METROPOLITAN GOVERNMENT OF NASHVILLE AND DAVIDSON COUNTY

STAFF RECOMMENDATION
106 Rosebank Avenue
June 17, 2020

Application: New Construction—Infill and Outbuilding; Setback Determination
District: Eastwood Neighborhood Conservation Zoning Overlay
Council District: 06
Map and Parcel Number: 08303036600
Applicant: Justin Crandall
Project Lead: Sean Alexander, sean.alexander@nashville.gov

Description of Project: The applicant proposes to construct a new single-family home with an outbuilding.

A-1.3

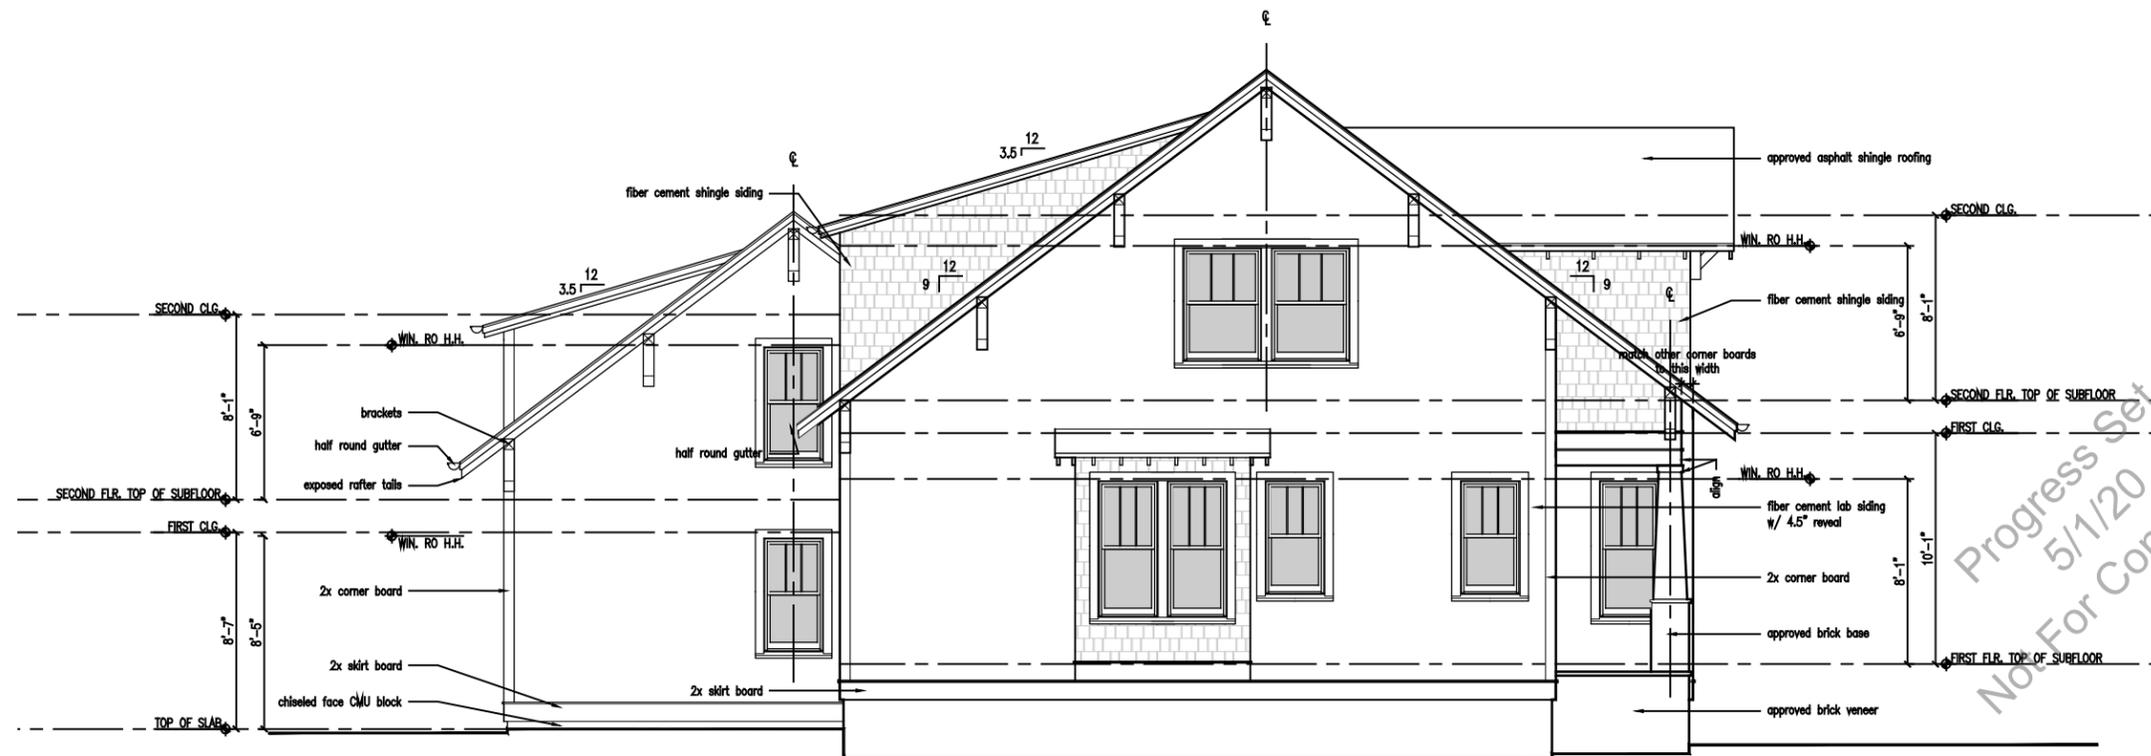
Roof form: The roof will be side-gabled with a 9/12 pitch and includes a gabled dormer on the front slope. The front dormer is shown with its front wall in line with the front wall of the first story below, whereas dormers typically are stepped back at least two feet (2') from walls below.

The pitch of the front dormer is 8/12, which is compatible with the pitch of the primary roof. There will also be a shed-roofed dormer on the rear slope of the roof. This dormer will be stepped in two feet (2') from the sides, but will not be stepped in from the rear wall below. Staff finds that the rear dormer is appropriate without having to be stepped in because the rear elevation is not visible from the right-of-way.

A-2.1

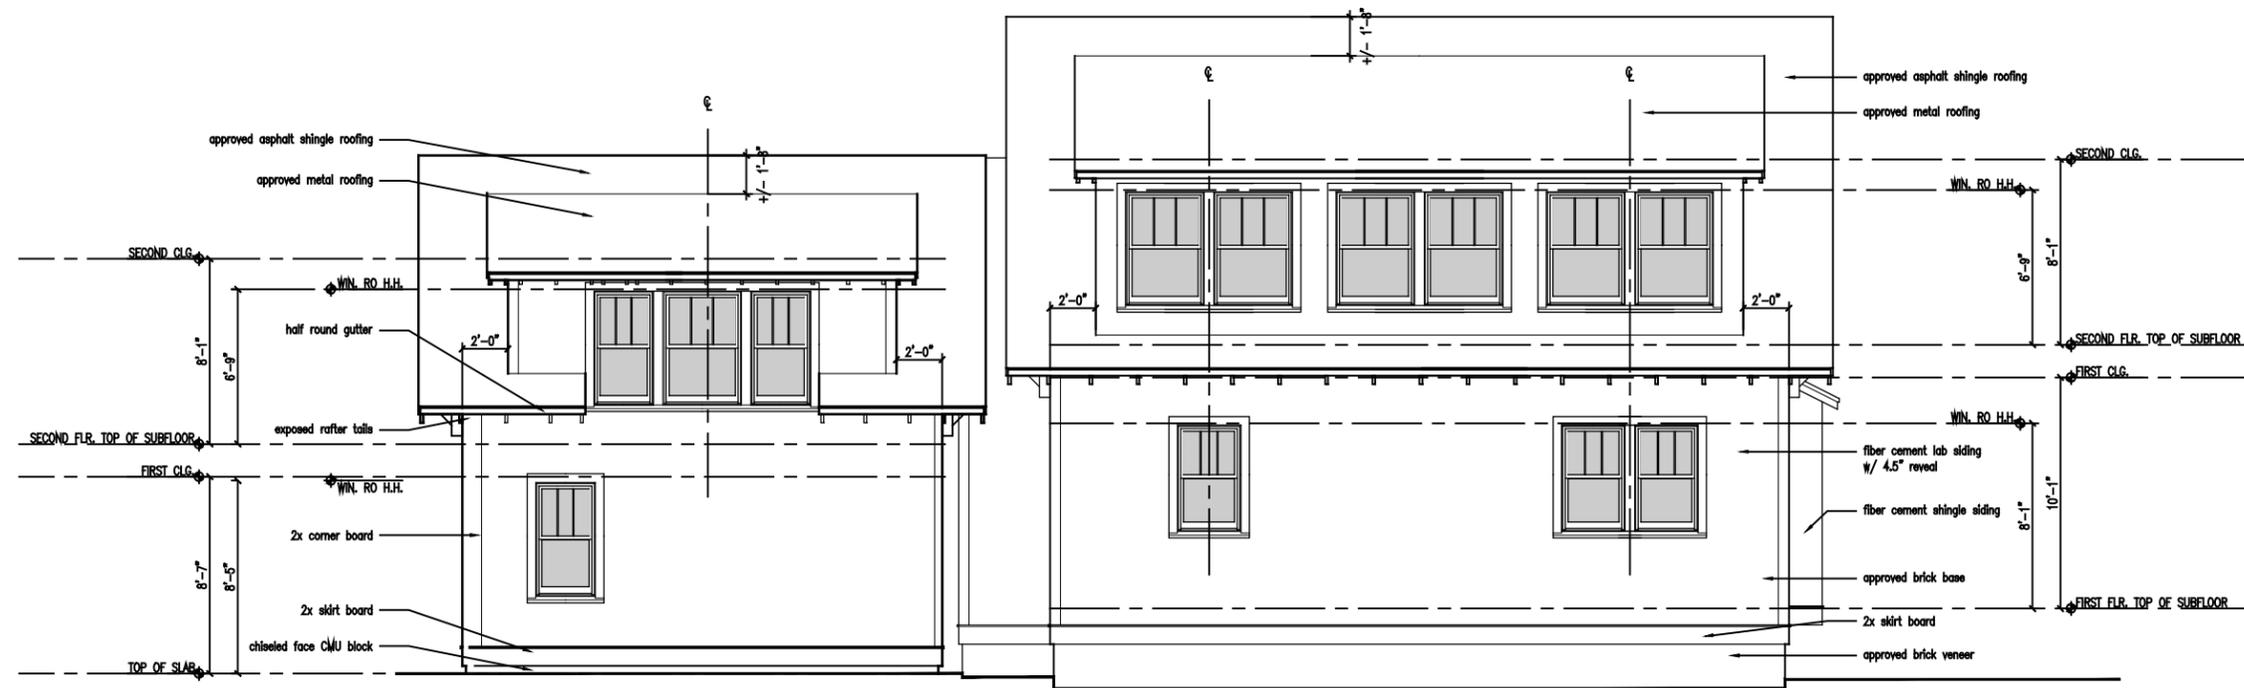
Height & Scale: The proposed infill will be one and one-half stories, with a ridge height at twenty-nine feet (29') above grade, an eave height of thirteen feet (13') from grade and a foundation height of three feet (3'). Although there are recent infill houses on the street as tall as twenty-seven feet (27') there are no historic houses on the block taller than twenty-five feet (25'). Staff recommends that the height of the building be decreased to be no taller than twenty-five feet (25') tall from grade.

On the left side of the house, the plans indicate that there will be a two foot (2') wide cantilevered bay. While a small bay would not necessarily be incompatible with the context in scale and design, as proposed, the bay would encroach two feet (2') into the left side setback. Staff recommends eliminating the bay, or shifting the location of the house to the right in order to meet the setback.

With a condition that the front dormer is stepped back at least two feet (2') from the wall below, staff finds that the roof form and pitches are compatible with the historic context and meet section II.B.e of the design guidelines.

1. The roof height of the house shall not exceed twenty-five feet (25');
2. The house shall meet the left and right side setbacks;
3. A walkway shall be constructed to connect the porch to the right-of-way in front of the house;
4. The front dormer on the house shall stepped back at least two feet (2') from the wall below; and
5. The eave height on the outbuilding shall be not taller than ten feet (10') tall; and
6. The dormers on the outbuilding shall be stepped back at least two feet (2') from the wall below and shall not exceed fifty percent (50%) of the width of the roof.
